ADDENDUM TO SPECIFICATIONS ENTITLED "SCC-TRB ACADEMIC AREA ROOF RECOVER PROJECT" DATED May 2025

<u>ADDENDUM NO. 1</u> <u>Jume 19, 2025</u>

The Specifications and Drawings contained in the project manual "SCC-TRB Academic Area Roof Recover Project" and dated May 2025 are amended as follows:

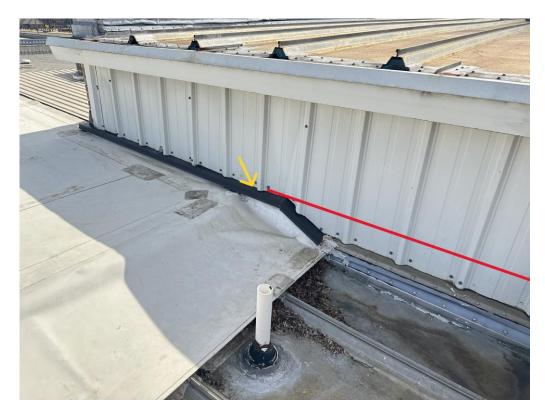
- a) A question was asked regarding if the flute fill insulation needs to be tapered or can it be straight cut?
 - The EPS flute fill insulation needs to be tapered cut.
- b) A question was asked regarding the wall transition between RA 5 and RA 9.
 - The current condition at the transition between the field of the roof at RA 6 (Not in contract) and the vertical wall panels below RA 9 should simply be continued straight across with the wall panels being cut to accommodate the continuation of the metal apron flashing to the corner of the wall. See included marked up photo of this condition for clarification.
